**BEFORE THE IDAHO PUBLIC UTILITIES COMMISSION**

**IN THE MATTER OF IDAHO POWER** )  
**COMPANY’S 2023 INTEGRATED** ) **CASE NO. IPC-E-23-23**  
**RESOURCE PLAN** )  
)  
)  
) **COMMENTS OF THE**  
) **COMMISSION STAFF**  
)  
\_\_\_\_\_)

**COMMISSION STAFF (“STAFF”) OF** the Idaho Public Utilities Commission, by and through its Attorney of record, Chris Burdin, Deputy Attorney General, submits the following comments.

Figure No. 1: Model of a Hypothetical Dispatchable Resource Portfolio

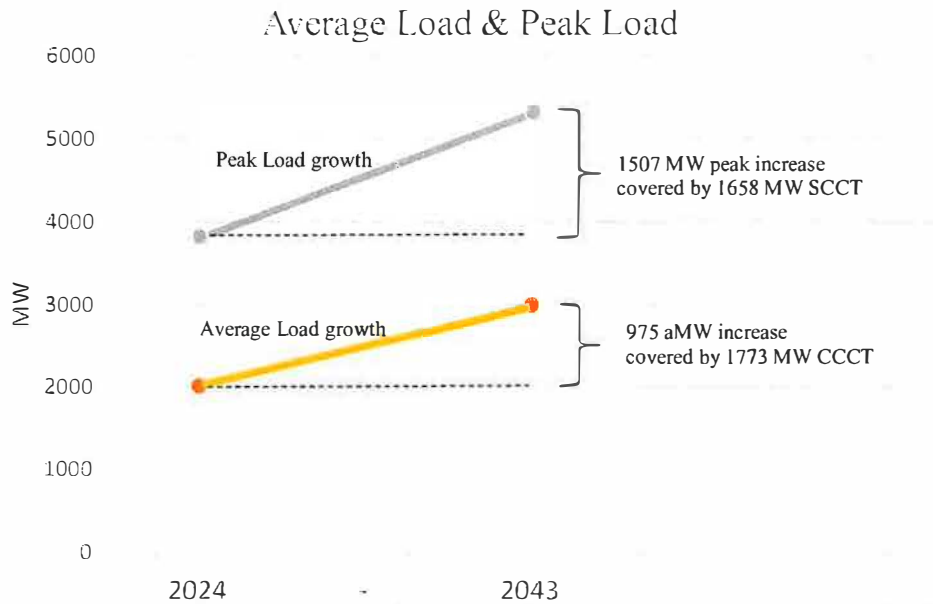
To perform a high-level check on the cost-effectiveness of the Company’s solution, Staff created a simplified model of the load requirement, and devised a hypothetical way to satisfy it using a combination of baseload and peaking dispatchable resources. The average load increase of 975 aMW can be hypothetically satisfied by a single Combined-Cycle Combustible Turbine (“CCCT”) gas plant, adjusted for its Capacity Factor (“CF”). Similarly, the peak load increase of 1,507 MW can be hypothetically satisfied by a single peaking resource, a Simple-Cycle Combustion Turbine (“SCCT”), adjusted for its CF. Staff understands that this solution is simplistic, and multiple smaller dispatchable resources would be more likely, but it serves as a reasonable basis to compare order-of-magnitude costs. This model is illustrated in Figure No. 1 below.

Using the cost inputs and operating assumptions from the IRP Appendix C, page 21, Staff calculated that this dispatchable portfolio would cost approximately \$6.7 billion to build in the first planning year and operate for 20 years. This is \$3.2 billion less than the NPV cost of the Preferred Portfolio.

To compare the two portfolio costs more fairly, Staff recalculated the VER and BESS portions of the Preferred Portfolio cost by using the same method as the dispatchable portfolio. By assuming both portfolios are fully built in year one, with 20 years of operating costs, the portfolios can be evenly compared. The results show the VER and BESS portfolio has an up-front cost estimate of \$13.9 billion, more than \$7 billion more expensive than the dispatchable portfolio. Staff calculations are shown in Table No. 3 below.
